Warrington Updated Proposed Submission Version Local Plan (2021-2038)

Detailed Planning Representations on behalf of Homes England and Miller Homes

15th November 2021

Appendix 1: Principal Landowner Boundaries

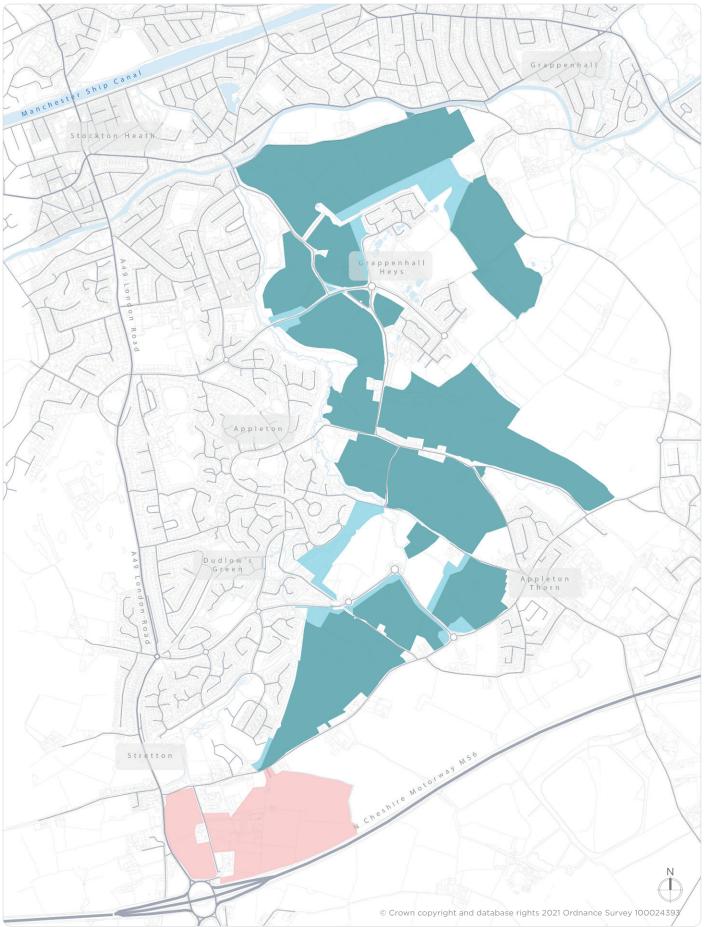
- **1.3.** A plan showing the extent of Homes England and Miller Homes' land interests relevant¹ to the proposed allocation is provided at Appendix 1.
- 1.4. Homes England is the Government's housing accelerator. The Agency has the appetite, influence, expertise, and resources to drive positive market change. By releasing more land to developers who want to make a difference, Homes England is making possible the new homes England needs, helping to improve neighbourhoods and grow communities. Homes England has a strong track record of delivering sustainable growth in Warrington and has considerable experience of promoting and delivering large scale residential-led development across England.
